**DATE:** Final April 18, 2019. *Revised May 20, 2019*

**FROM:** Corky Poster, Architect/Planner (AICP)  
City of Tucson On-Call Design Professional

**RE:** IID-18-08  
Related Activity Numbers: DP-19-0018, T18PRE0123  
141 South Stone Avenue, Tucson, AZ

INFILL INCENTIVE DISTRICT DESIGN PACKAGE FOR HILTON DUAL BRAND HOTEL, submittal from applicant, dated February 2019. Materials as noted, following (8.5 x 11 Format):

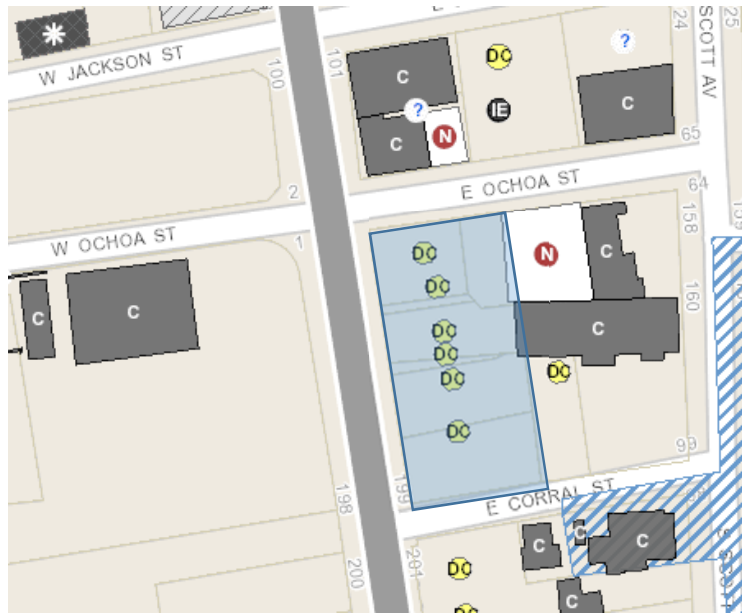
(a) Listed or eligible to be listed in the National Register of Historic Places, individually or as a contributing property [*applicable here. See map below “C”*]
